Manufacturing Notice

Name:	Plating New Installation Rims
-------	-------------------------------

Affected Parts:	All two piece "New Installation" Custom Cupholder Company top appearance rims.
Part Name:	Top Appearance Rim

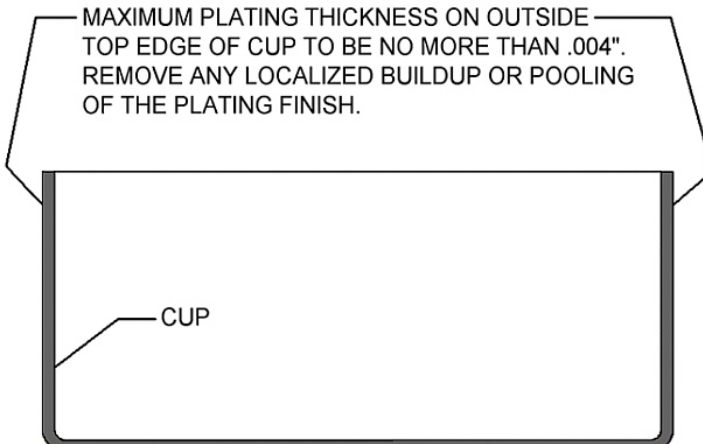
Notice:	<p style="text-align: center;"><u>IMPORTANT PLATING INFORMATION</u></p>  <p style="text-align: center;">MAXIMUM PLATING THICKNESS ON INSIDE OF RIM FLANGE TO BE NO MORE THAN .004". REMOVE ANY LOCALIZED BUILDUP OR POOLING OF PLATING FINISH.</p>
---------	---
